# CUB AURORA PLAZA SITE PLAN

## USE APPROVAL

ADMINISTRATIVE AMENDMENT 8/12/87

CUB AURORA PLAZA E&F 709134-1

ADMINISTRATIVE AMENDMENT AUGUST 12, 1987  
OCTOBER 16, 1986 JUN 1988 SHEET 1 OF 2

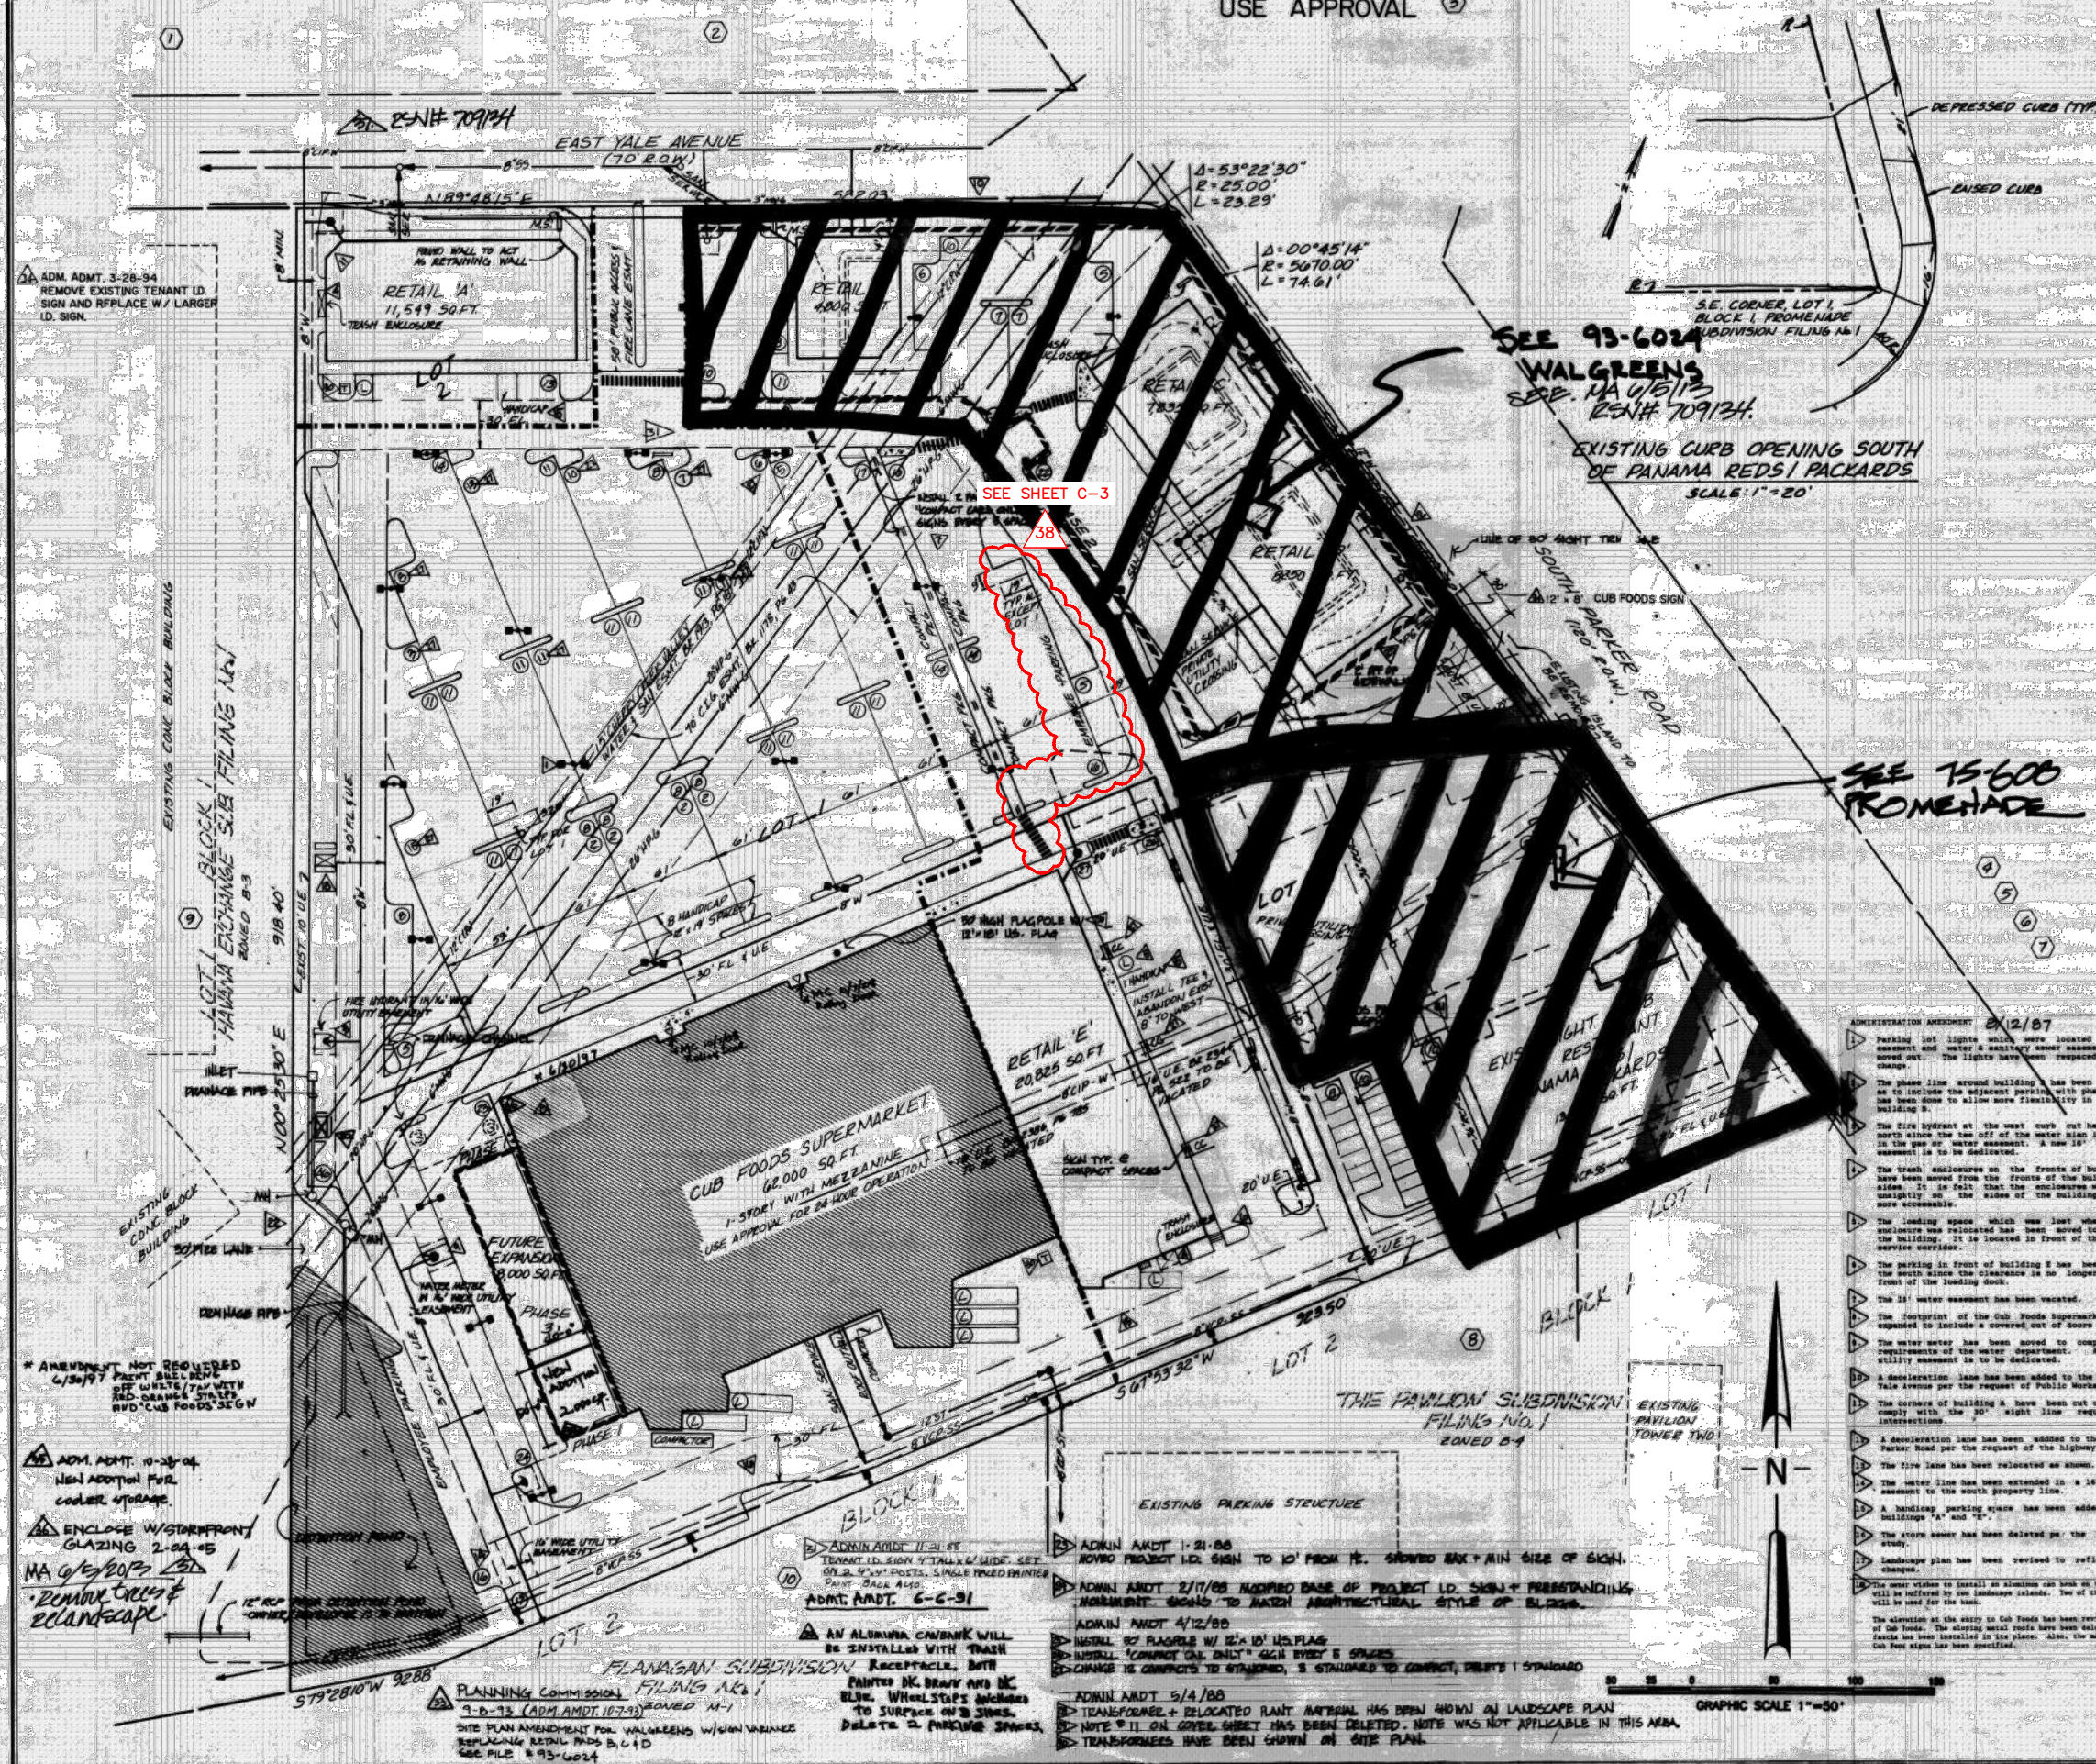
Parking lot lights which were located in the gas easement and under a sanitary sewer easement have been moved out. The lights have been replaced due to this change.

The phase line around building 8 has been relocated so as to include the adjacent parking with phase two. This has been done to allow more flexibility in the design of building 8.

The fire hydrant at the west curb cut has been moved north since the toe off of the water main is not allowed in the gas or water easement. A new 18" wide utility easement is to be dedicated.

The trash enclosure on the fronts of buildings A & S have been moved from the fronts of the buildings to the sides. It is in fact that the enclosure will be less unsightly on the sides of the buildings and also be more accessible.

The loading space which was just when the trash enclosure was relocated has been moved to the front of the building. It is located in front of the door to a service corridor.

The parking in front of building 8 has been expanded to the south since the clearance is no longer required in front of the loading dock.

The 18" water easement has been vacated.

The footprint of the Cub Foods Supermarket has been expanded to include a covered, out of door sales area.

The water meter has been moved to comply with the requirements of the water department. A new 18" wide utility easement is to be dedicated.

A dedication lane has been added to the south side of Yale Avenue per the request of Public Works.

The corners of building 8 have been cut off at 45° to comply with the 30' sight line requirements for intersections.

A dedication lane has been added to the west side of Parker Road per the request of the Highway Department.

The fire lane has been relocated as shown.

The water line has been extended in a 18" wide utility easement to the south property line.

A handicap parking space has been added in front of buildings "A" and "E".

The storm sewer has been deleted per the final drainage study.

The meter vaults to install an aluminum can bank on the site. The bank will be utilized by the landscape architect. Two of the parking spaces will be used for the bank.

The elevation at the entry to Cub Foods has been revised per the request of Cub Foods. The existing metal rods have been deleted and a metal fence has been installed in its place. Also, the minimum size of the Cub Foods sign has been specified.

OCTOBER 15, 1988 JOB NO. 100,361 SHEET 2 OF 2

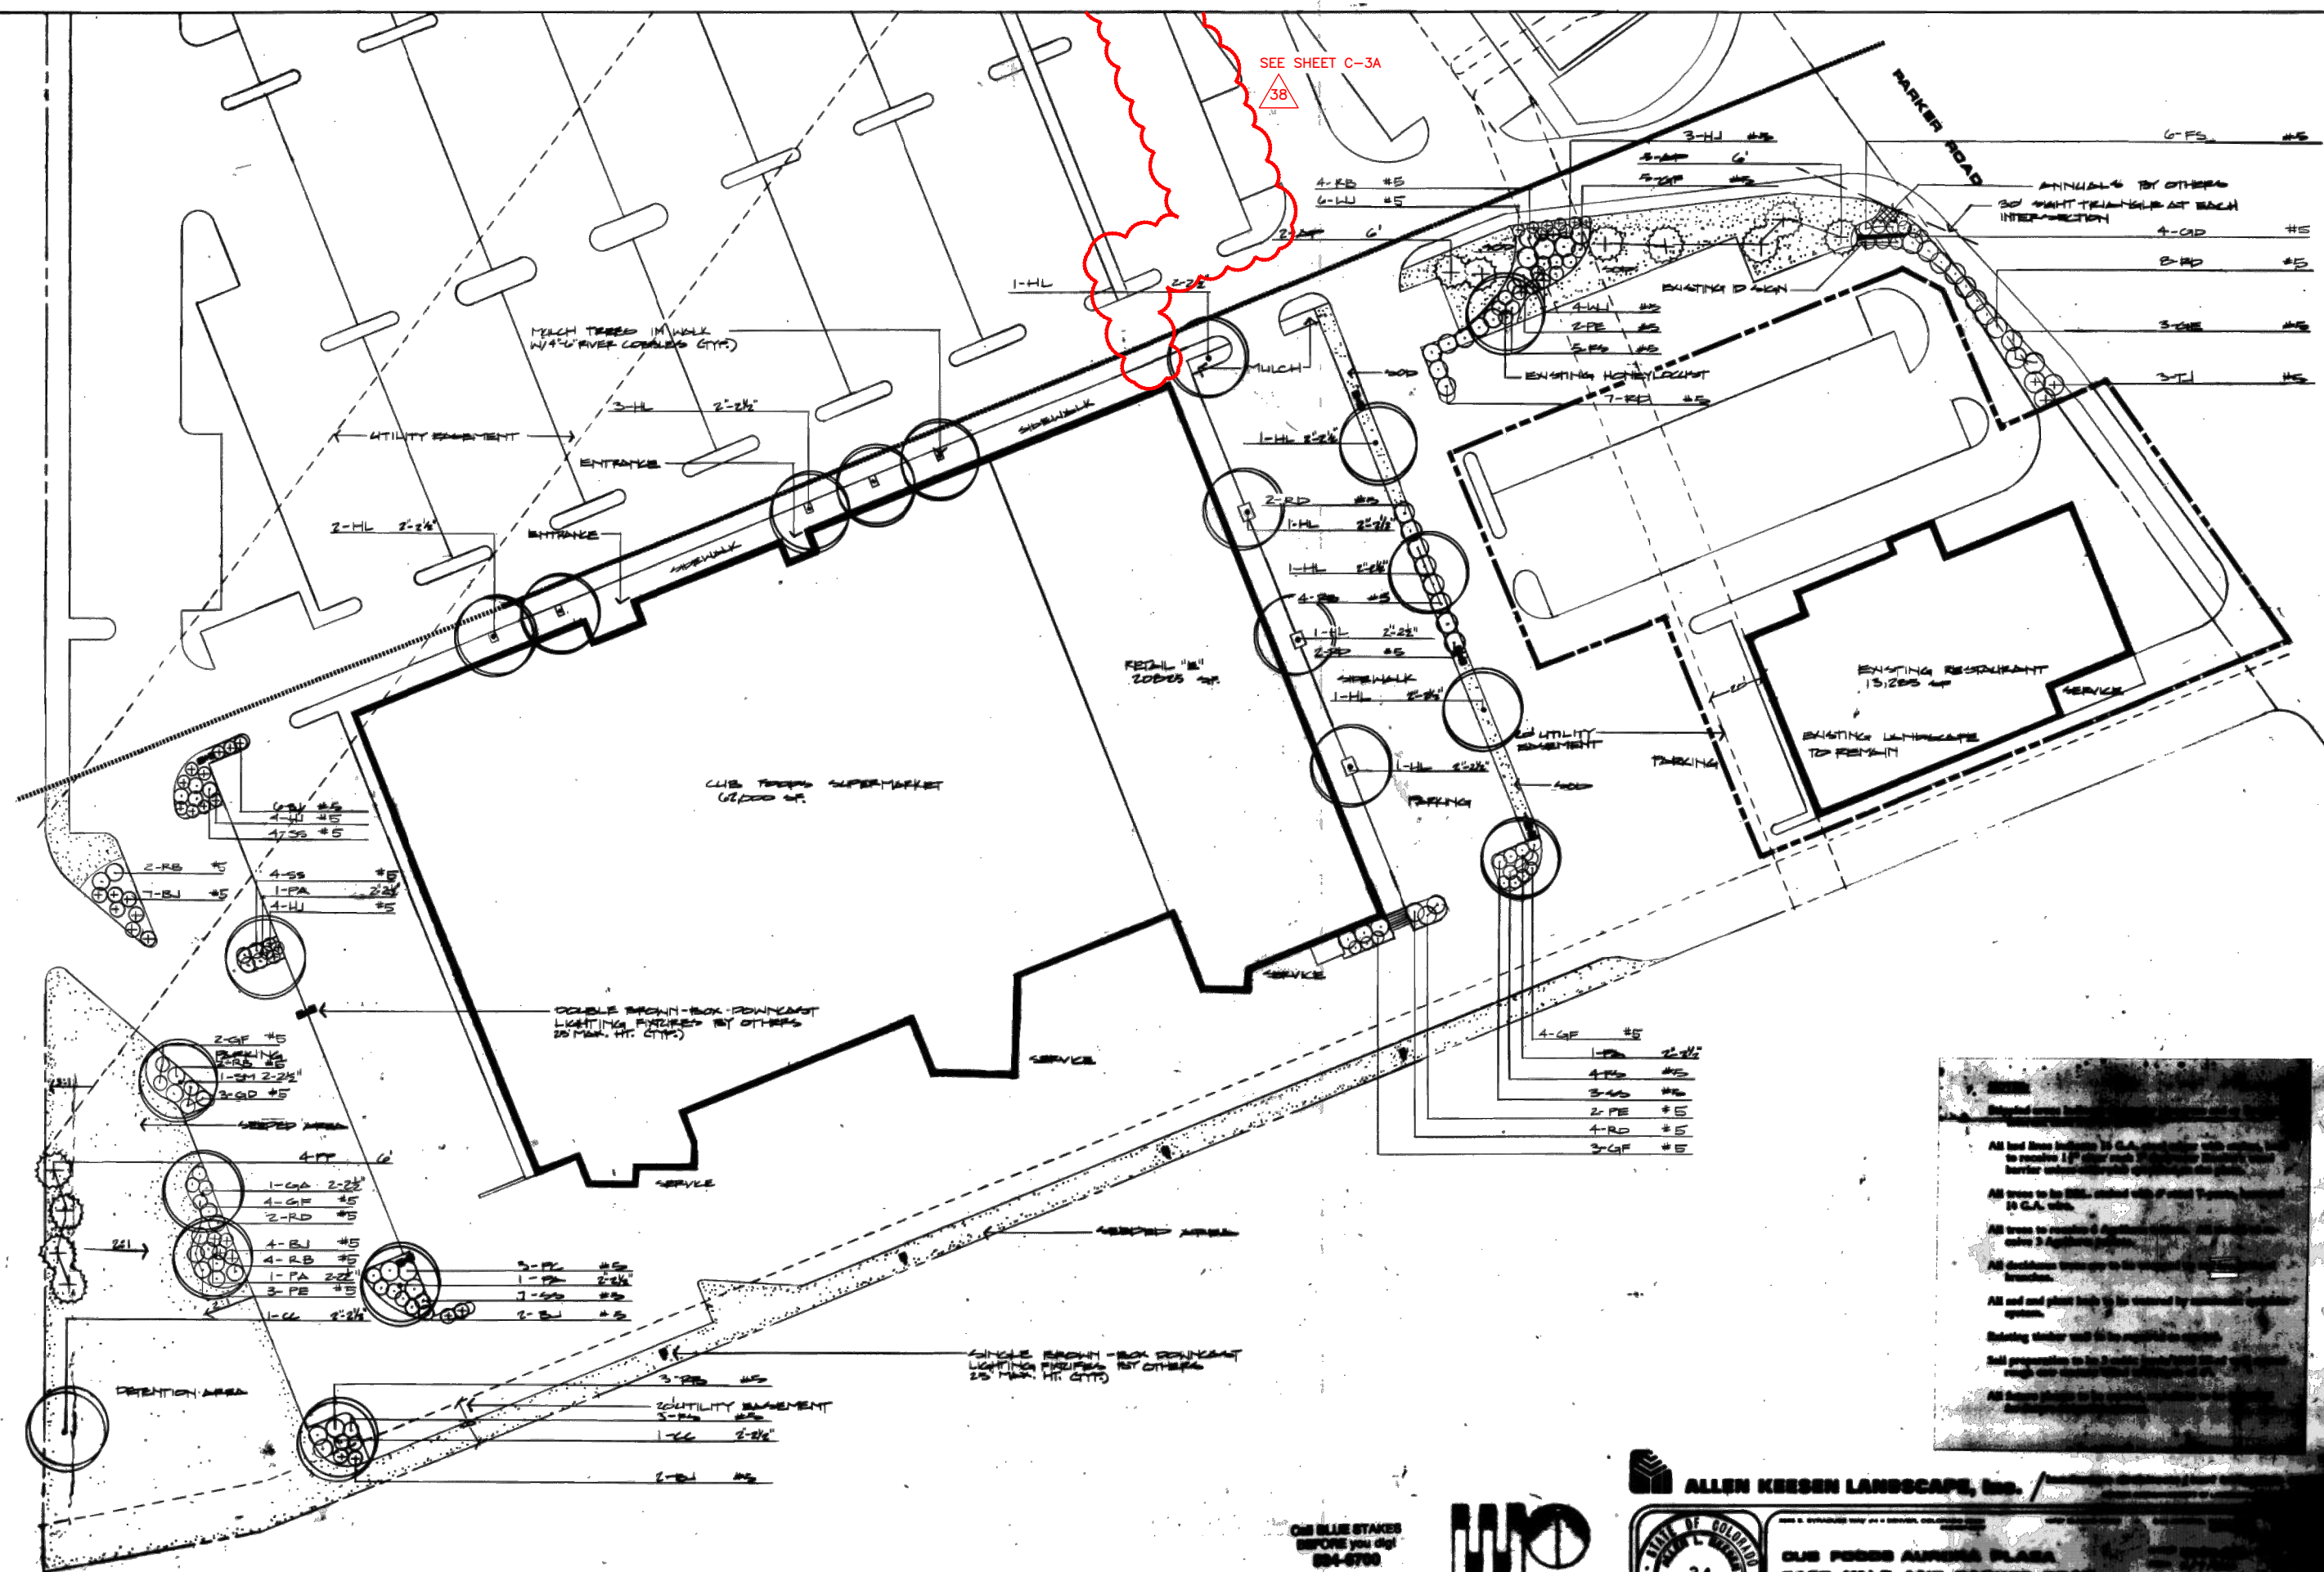
REVISED NOTE #8 ON SHEET 1 OF 2 TO ALLOW MECH UNITS WHICH ARE NOT SCREENED BY THE 4" HIGH BARRIER WALL TO BE PAINTED IN CABINET.

LANDSCAPE ISLAND CHANGED TO PAINTED ISLAND LANDSCAPING RELOCATED WEST OF CUB FOODS

RELOCATE CURB CUT ON THE WEST PROPERTY LINE TO THE SOUTH ADD NEW STORM INLET & PIPE. DELETE 2 PARKING SPACES. CHANGE TRASH ENCLOSURE GATES FROM STEEL TO CEDAR.
